Subject: SSR Software Change
Applicable Products: SSR Series Products
Effectivity: 02/01/23

Introduction

Figure 1: SSR Motor Assembly P/N 56301 w/ Holding Software

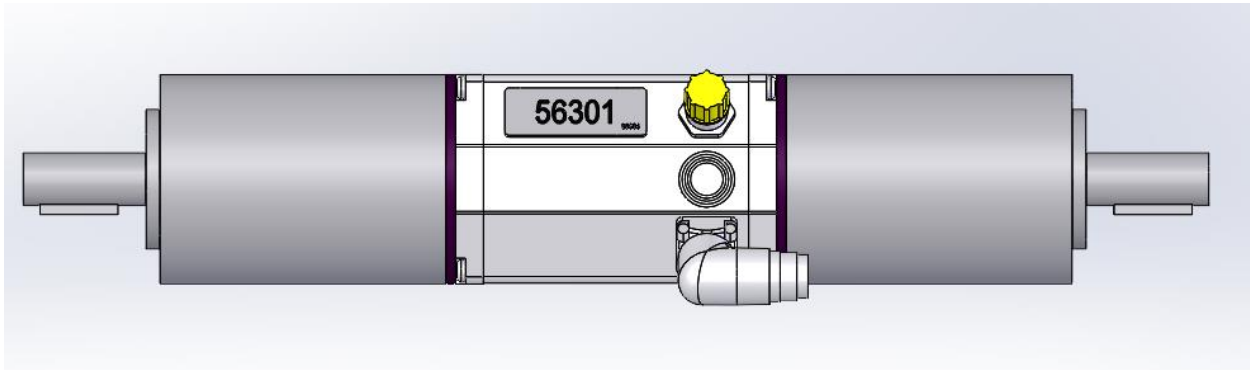
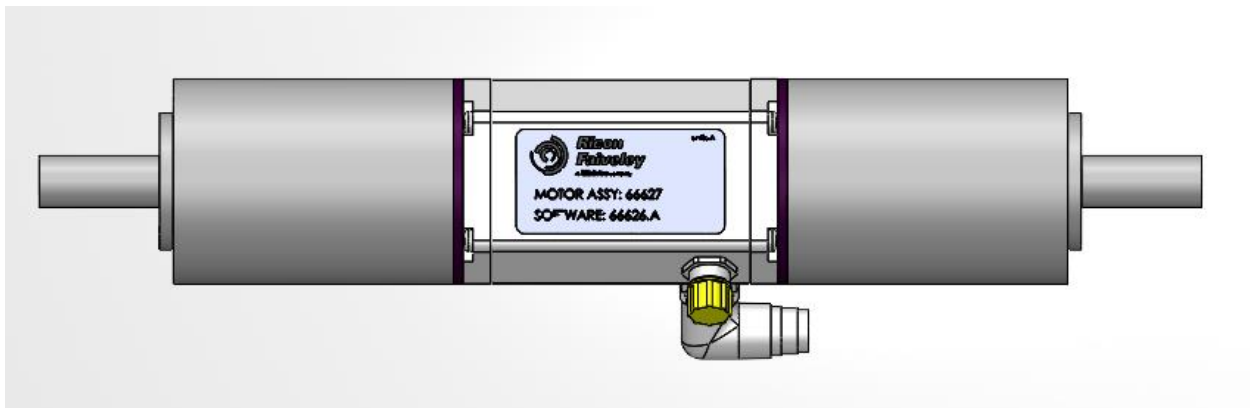
Ramp operation is changing due to the removal of the holding function to reduce the amount of force on the ramp plate cam followers.

- **Holding Function:** During Deployment or Stowage of the ramp, if an operator releases the Deploy or Stow dash switch while ramp is in motion, the ramp stops and hold this position.
- **Manual Operation:** Operator must turn off ramp power via the dash switch to allow the manual operation of the ramp. Failure to do so will exert high forces on the cam followers that may cause them to yield.

- **No Holding Function:** During Deployment or Stowage of the ramp, if an operator releases the Deploy or Stow dash switch while ramp is in motion, the ramp will halt motion and coast down to a stop. The new software will no longer allow the ramp to hold a position in ramp travel. During the coast down of the ramp, an operator can reverse the motion of the ramp using the dash switch.
- **Manual operation:** Operators are no longer required to turn off the ramp power at the dash switch to manually Stow or Deploy the ramp. This will ensure minimal forces are exerted on the cam followers.

- Removed: Holding current that holds ramp plate in place when the Deploy or Stow dash buttons are released.
- Added: Coast down feature when the Deploy or Stow dash buttons are released.
- Added: Ramp reversal feature during coast down of ramp plate

Software change should be implemented on new production units, or field modified units by trained Ricon professionals only. The ramp timing must be properly adjusted to work with the new no-hold software. Failure to properly adjust the timing will result in the rapid descent of the ramp plate, creating a potential safety hazard to operators and/or passengers.
